No. 5:20-cv-06249-JMG

**CONSENT ORDER BETWEEN PLAINTIFF UNITED STATES AND THE VIEWS AT
PINE VALLEY I, LP**

CEDAR VIEWS APARTMENTS – RETROFIT PLAN

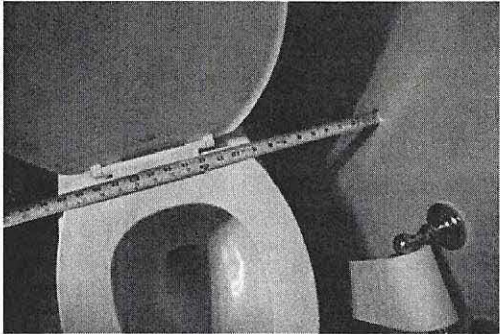
Inaccessible Feature	Photograph(s)	Retrofit(s)
D.15.	<p>The kitchen sink is located in a corner and has a base cabinet. The parallel clear floor space is about 16 1/2" wide.</p> <p>Clear floor space at the kitchen sink must be at least 30" by 48" and centered.</p> <p>(FHA Guidelines Req. 7(1)(a))</p>	 <p>(DSC00831.jpg – Unit 317)</p>	<p>Design the reconfiguration of the kitchen to provide a compliant parallel or forward approach and submit the design to DOJ for review and approval. Include removable sink base if forward approach is used. Renovate the kitchens consistent with the approved design, including necessary repair or replacement of finishes, flooring, and counter supports.</p>

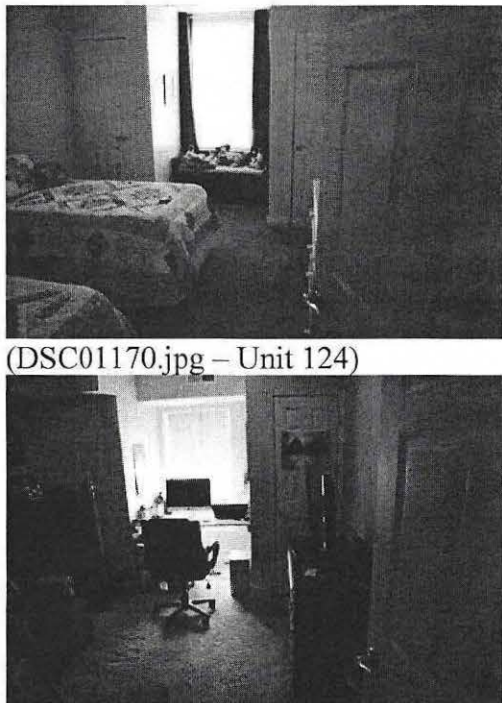
Inaccessible Feature	Photograph(s)	Retrofit(s)
D.18.	<p>The kitchen sink is located in a corner and has a base cabinet. The parallel clear floor space is about 16 1/2" wide.</p> <p>Clear floor space at the kitchen sink must be at least 30" by 48" and centered.</p> <p>(FHA Guidelines Req. 7(1)(a))</p>	 <p>(DSC00970.jpg – Unit 224)</p>	<p>Design the reconfiguration of the kitchen to provide a compliant parallel or forward approach and submit the design to DOJ for review and approval. Include removable sink base if forward approach is used. Renovate the kitchens consistent with the approved design, including necessary repair or replacement of finishes, flooring, and counter supports.</p>

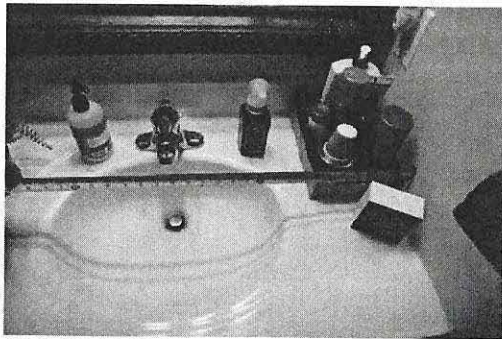
Inaccessible Feature	Photograph(s)	Retrofit(s)
D.20.	<p>The threshold to the hall bathroom, where the laundry equipment is located, is 1/2" tall and is not beveled 1:2 on the bathroom side.</p> <p>The dwelling unit entrance is in an interior corridor. The threshold cannot be taller than 1/2". Where the top of the threshold is more than 1/4" above the landing, the transition must be beveled at least 1:2.</p> <p>(FHA Guidelines Req. 4(4))</p>	 <p>(DSC01053.jpg – Unit 17)</p>	<p>Modify or replace threshold so that it is no taller than 1/2" and, if necessary, beveled at least 1:2 with a vertical edge that is no taller than 1/4".</p>
D.21.	<p>The kitchen sink is located in a corner and has a base cabinet. The parallel clear floor space is about 16 1/2" wide.</p> <p>Clear floor space at the kitchen sink must be at least 30" by 48" and centered.</p> <p>(FHA Guidelines Req. 7(1)(a))</p>	 <p>(DSC01082.jpg – Unit 17)</p>	<p>Design the reconfiguration of the kitchen to provide a compliant parallel or forward approach and submit the design to DOJ for review and approval. Include removable sink base if forward approach is used. Renovate the kitchens consistent with the approved design, including necessary repair or replacement of finishes, flooring, and counter supports.</p>

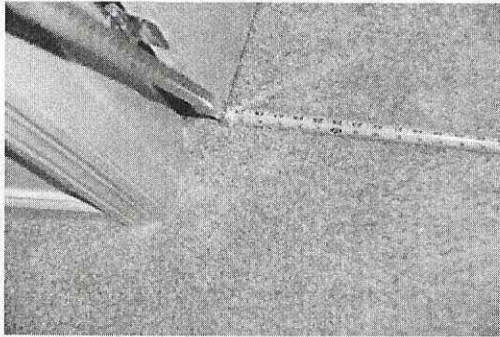
Inaccessible Feature	Photograph(s)	Retrofit(s)
<p>D.22. In the master bathroom, the toilet centerline is 14 1/2" from the sidewall.</p> <p>Toilet centerline must be at least 18" from the sidewall or bathtub.</p> <p>(FHA Guidelines Req. 7(2)(a)(ii) or 7(2)(b)(iv))</p> <p>(Note: This issue was observed in Unit 17 but not in Unit 211.)</p>	 <p>(DSC01058.jpg – Unit 17)</p>	<p>Retrofit toilets that have either of the following inaccessible features on the far side of the fixture:</p> <ul style="list-style-type: none"> c. Toilet centerlines that are less than 17" from an adjacent tub, shower, or wall surface that is less than 28" in length; or d. Toilet centerlines that are less than 15 1/2" from an adjacent side wall that is minimum 28" long. <p>Relocate toilet to position required by the safe harbor.</p> <p>Exception 1: where a toilet is less than 15-1/2" from an adjacent tub, shower, or wall surface located on the far side of the toilet and there is no 28" sidewall, relocate the toilet as far as possible towards the direction of approach using an offset flange. Document centerline conditions before and after relocation. Provide list of toilets affected by this exception and their centerline dimensions before and after relocation to the DOJ and the neutral inspector prior to the inspection.</p>

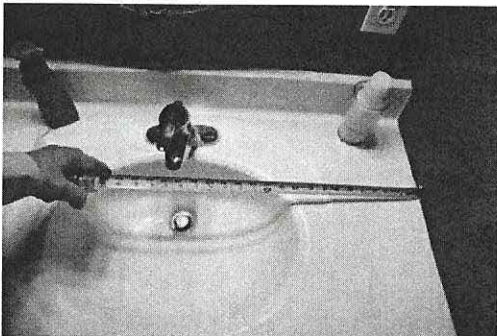
Inaccessible Feature	Photograph(s)	Retrofit(s)
			<p>Exception 2: notify DOJ prior to retrofitting toilet if there are unforeseen conditions affecting the relocation of the fixture. For example, if relocation of the toilet reduces near side clear space to less than 14", retrofit clearances may need to be adjusted.</p>

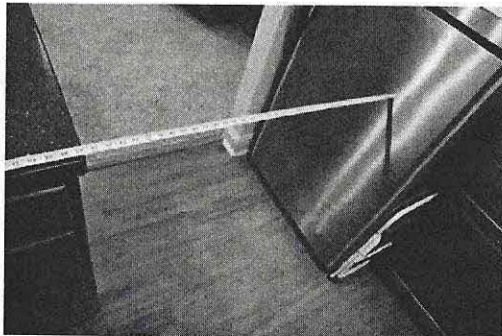
Inaccessible Feature	Photograph(s)	Retrofit(s)
D.24.	<p>The door to the powder room has a clear opening of 27 5/8". The laundry equipment is in this room.</p> <p>Door clear opening must be at least 31 5/8".</p> <p>(FHA Guidelines Req. 3(2))</p> <p>(Note: This issue was observed in Unit 326 but not in Unit 124.)</p>	No photograph taken.	Replace and reframe door to provide at least 31 5/8" clear opening.
D.25.	<p>The kitchen sink is located in a corner and has a base cabinet. The parallel clear floor space is about 16 1/2" wide.</p> <p>Clear floor space at the kitchen sink must be at least 30" by 48" and centered.</p> <p>(FHA Guidelines Req. 7(1)(a))</p>	 <p>(DSC01176.jpg – Unit 124)</p>	Design the reconfiguration of the kitchen to provide a compliant parallel or forward approach and submit the design to DOJ for review and approval. Include removable sink base if forward approach is used. Renovate the kitchens consistent with the approved design, including necessary repair or replacement of finishes, flooring, and counter supports.

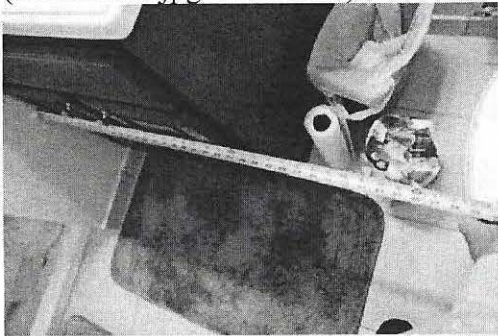
Inaccessible Feature	Photograph(s)	Retrofit(s)
Type G – 2 Bedroom, 1.5 Bath (3 Units of this Type) (Surveyed Units: 222 and 422)		
<p>D.27. The master bedroom walk-in closet is 36" deep and the clear opening is 29 1/2".</p> <p>If the closet is deeper than 24", the closet door is intended for user passage. It must provide at least 31 5/8" clear opening.</p> <p>(FHA Guidelines Req. 3(2))</p>	 <p>(DSC01320.jpg – Unit 222)</p>	<p>If feasible (i.e., where the closet is at least 36" wide) remove door and install cased opening to provide at least 31 5/8" clear opening.</p> <p>If not feasible, post laminated notice in the closet notifying the resident that closet fittings (shelves and hanging rod/bar) can be relocated or depth of closet reduced to 24" on request of the resident. Submit wording for notice to DOJ for review prior to printing notice.</p>
<p>D.28. The kitchen sink is located in a corner and has a base cabinet. The parallel clear floor space is about 16 1/2" wide.</p> <p>Clear floor space at the kitchen sink must be at least 30" by 48" and centered.</p> <p>(FHA Guidelines Req. 7(1)(a))</p>	 <p>(DSC01333.jpg – Unit 222)</p>	<p>Design the reconfiguration of the kitchen to provide a compliant parallel or forward approach and submit the design to DOJ for review and approval. Include removable sink base if forward approach is used. Renovate the kitchens consistent with the approved design, including necessary repair or replacement of finishes, flooring, and counter supports.</p>

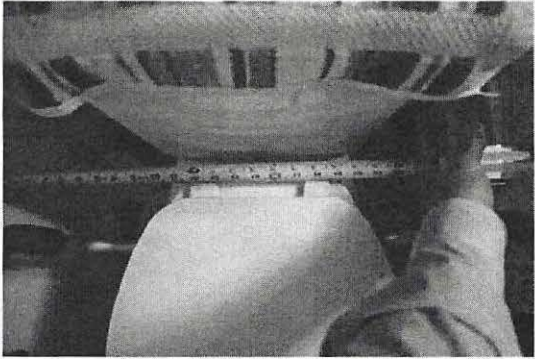
Inaccessible Feature	Photograph(s)	Retrofit(s)
<p>D.34. The parallel clear floor space for the lavatory in Unit 221 is about 40" long and is off-center by 12". The parallel clear floor space for the lavatory in Unit 319 is about 41 3/4" long and is off-center by 11 1/2". In both units, a forward approach is blocked by the vanity.</p> <p>Clear floor space for the lavatory must be at least 30" by 48". It must be centered. If forward, knee and toe space must be provided under the lavatory.</p> <p>(FHA Guidelines Req. 7(2)(a)(ii) or 7(2)(b)(v))</p>	 <p>(DSC01300.jpg – Unit 221)</p>  <p>(DSC01229.jpg – Unit 319)</p>	<p>Relocate lavatory or replace vanity with unit that has a removable cabinet.</p>

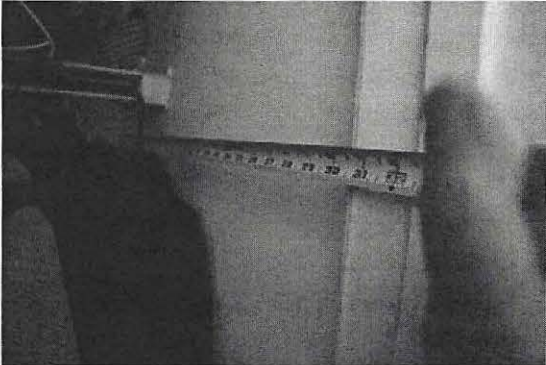
Inaccessible Feature	Photograph(s)	Retrofit(s)
<p>D.36. The kitchen sink is located in a corner and has a base cabinet. The parallel clear floor space is about 16 1/2" wide.</p> <p>Clear floor space at the kitchen sink must be at least 30" by 48" and centered.</p> <p>(FHA Guidelines Req. 7(1)(a))</p>	 <p>(DSC01408.jpg – Unit 16)</p> <p>(DSC01150.jpg – Unit 18)</p>	<p>Design the reconfiguration of the kitchen to provide a compliant parallel or forward approach and submit the design to DOJ for review and approval. Include removable sink base if forward approach is used. Renovate the kitchens consistent with the approved design, including necessary repair or replacement of finishes, flooring, and counter supports.</p>

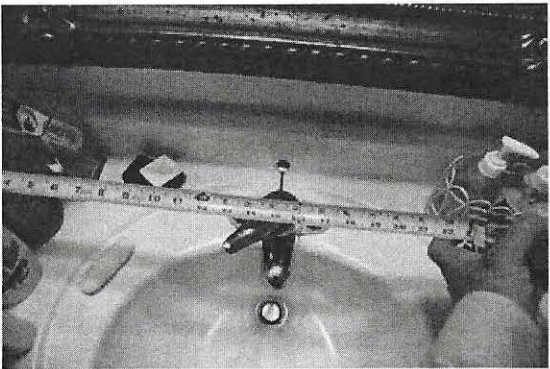
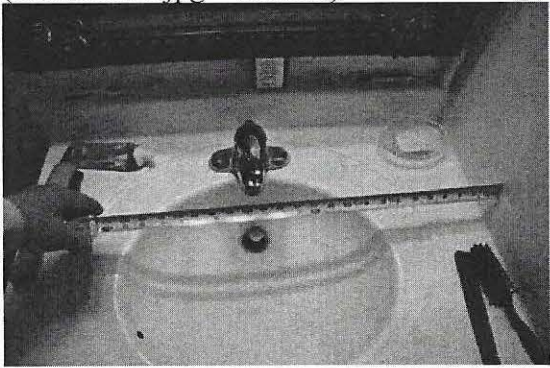
Inaccessible Feature	Photograph(s)	Retrofit(s)
D.39.	<p>In the master bathroom in Unit 18, the toilet centerline is 15 1/4" from the sidewall.</p> <p>Toilet centerline must be at least 18" from the sidewall or bathtub.</p> <p>(FHA Guidelines Req. 7(2)(a)(ii) or 7(2)(b)(iv))</p> <p>(Note: This issue was observed in Unit 18 but not in Unit 16.)</p>	 <p>(DSC01145.jpg – Unit 18)</p>	<p>Retrofit toilets that have either of the following inaccessible features on the far side of the fixture:</p> <ul style="list-style-type: none"> e. Toilet centerlines that are less than 17" from an adjacent tub, shower, or wall surface that is less than 28" in length; or f. Toilet centerlines that are less than 15 1/2" from an adjacent side wall that is minimum 28" long. <p>Relocate toilet to position required by the safe harbor.</p> <p>Exception 1: where a toilet is less than 15-1/2" from an adjacent tub, shower, or wall surface located on the far side of the toilet and there is no 28" sidewall, relocate the toilet as far as possible towards the direction of approach using an offset flange. Document centerline conditions before and after relocation. Provide list of toilets affected by this exception and their centerline dimensions before and after relocation to the DOJ and the neutral inspector prior to the inspection.</p>
